Rezoning Transportation Analysis

Petition Number: #2022-048

Revision Log:

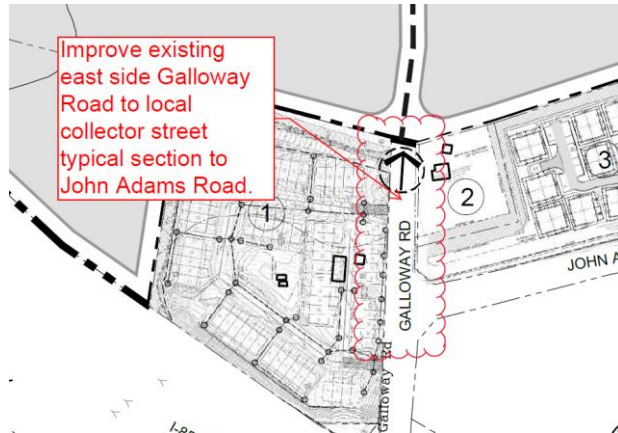
A Traffic Impact Study (TIS) is necessary for the complete review of this petition due to the site generating more than 2,500 daily trips. The petitioner submitted the Draft TIS Scoping Package on February 15, 2022, and CDOT provided comments on the Scoping Package on March 1, 2022. The Revised TIS was submitted to CDOT on 11/12/22, and is currently under review by CDOT.

Staff will receive the petition and begin review, but the public hearing will not be scheduled until the TIS is approved to allow for the minimum time necessary for CDOT to review the study and reach agreement with the petitioner on the required transportation commitments. Any agreed upon commitments shall be included on the last site plan submitted no fewer than 4 weeks prior to the public hearing. Therefore, additional traffic mitigation comments may be forthcoming once the TIS is approved by CDOT (and NCDOT).

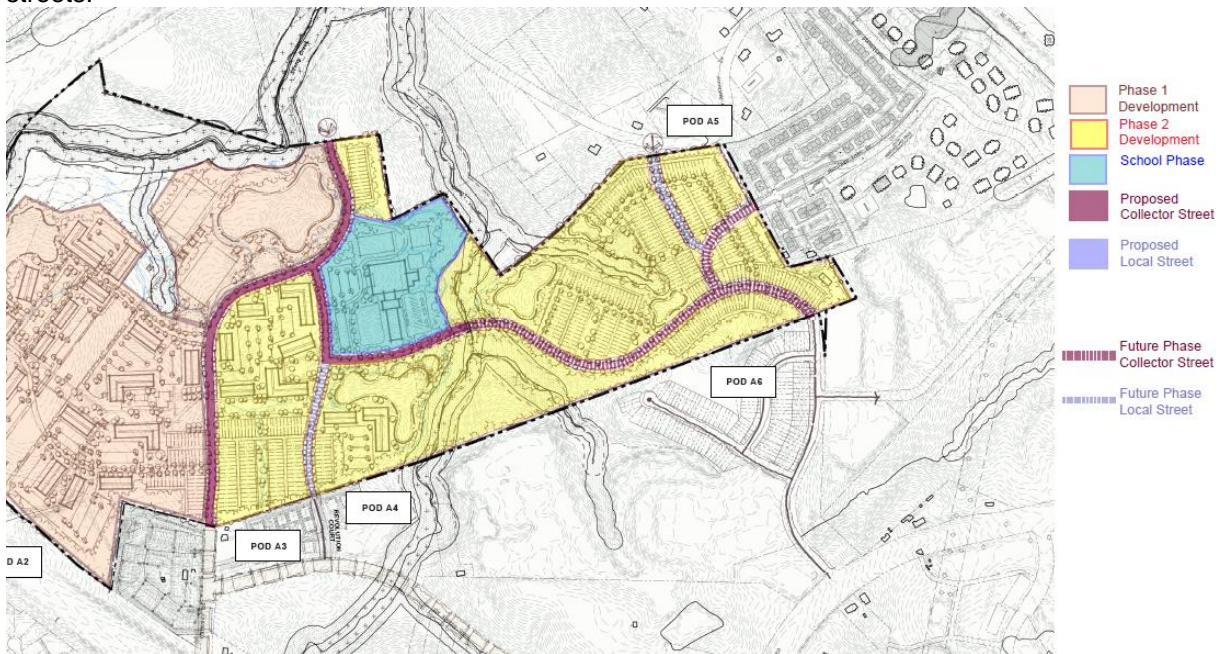
~~2. Outstanding Comment from 08-25-22: Revise site plan and conditional note(s) to commit to improving the existing Galloway Road stub to John Adams to the local collector street typical section per U-07.~~

- ~~3. Revise site plan and conditional note(s) to commit to the proposed roadway network typical sections and proposed phasing outlined in the Traffic Impact Study. Provide typical sections per CLDSM for all proposed public and private streets. Provide 8 foot sidewalk and 8 foot planting strip on all public streets.~~

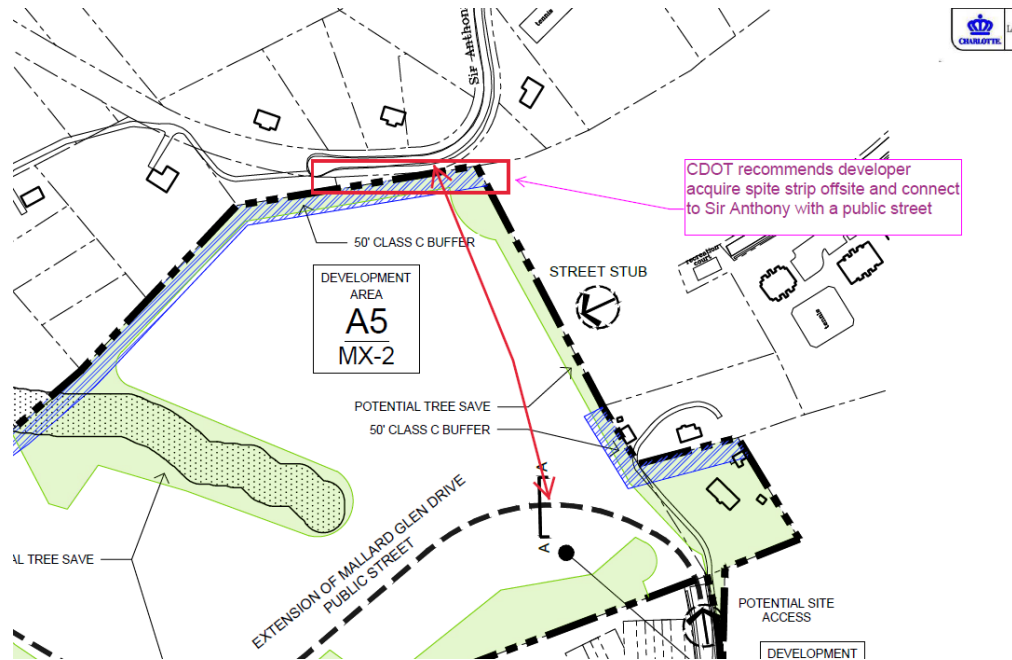
- ~~4. Add conditional Lighting Note for petitioner to coordinate with CDOT Lighting, Bruce Horltd (704-589-5836 or Bruce.Horltd@charlottenc.gov), prior to permitting of lighting fixtures on public roadways.~~
- ~~5. **CDOT RECOMMENDATION:** CDOT recommends the petitioner commit to providing a public street connection to Sir Anthony Drive.~~
